# Access Compliance Report

## Public Rights-of-Way

Intersection ID: 3117	Main Street: BASKERVILLE_AV	Cross Street: BUCKMINSTER_CT	Location:	E
ADA ID: 79DCB5FDE81C	Ramp Type: Perp	Initial Pass/Fail: Fail	Overall Compliance: No	Severity Score: 50
Codes/Mitigation Info/Possible Solution		Field Measurements/Component Compliance

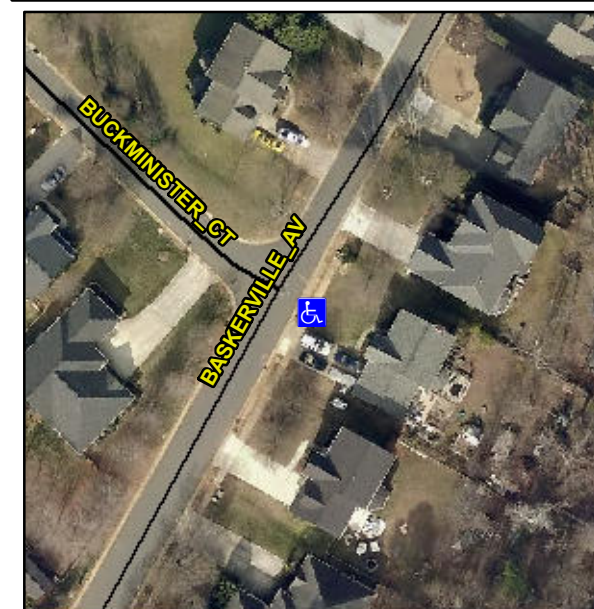
**Not Found, R304.2.2, R304.5.3**

Compliance	Description	Data	Compliance	Description	Data
N/A	Ramp Length (in)	48.0	No	Ramp Slope (%)	12.2
Yes	Ramp Width (in)	48.0	No	Ramp XSlope (%)	12.7
N/A	Flare Type LT	N/A	N/A	Flare Type RT	N/A
N/A	Flare Slope LT (%)	N/A	N/A	Flare Slope RT (%)	N/A
N/A	Flare Traversable LT?	N/A	N/A	Flare Traversable RT?	N/A
N/A	Landing Length (in)	N/A	N/A	DWS Provided?	N/A
N/A	Landing Width (in)	N/A	N/A	DWS Contrast?	N/A
N/A	Landing Slope (%)	N/A	N/A	DWS Length (in)	N/A
N/A	Landing X Slope (%)	N/A	N/A	DWS Full Width?	N/A
N/A	Landing Curb? (Y/N)	N/A	N/A	DWS Offset (in)	N/A
N/A	Shared Landing?	N/A			
N/A	Gutter Ponding?	N/A	N/A	Gutter Slope (%)	N/A
N/A	Gutter Lip Ht (in)	N/A	N/A	Gutter X Slope (%)	N/A
N/A	Painted X Walk1?	No	N/A	Painted X Walk2?	N/A
	X Walk 1 Direction	To NW		X Walk 2 Direction	N/A
N/A	X Walk 1 Width (in)	N/A	N/A	X Walk 2 Width (in)	N/A
	X Walk 1 Slope (%)	4.4		X Walk 2 Slope (%)	N/A
	X Walk 1 X Slope (%)	9.8		X Walk 2 X Slope (%)	N/A

**Remove & Replace Entire Ramp.**
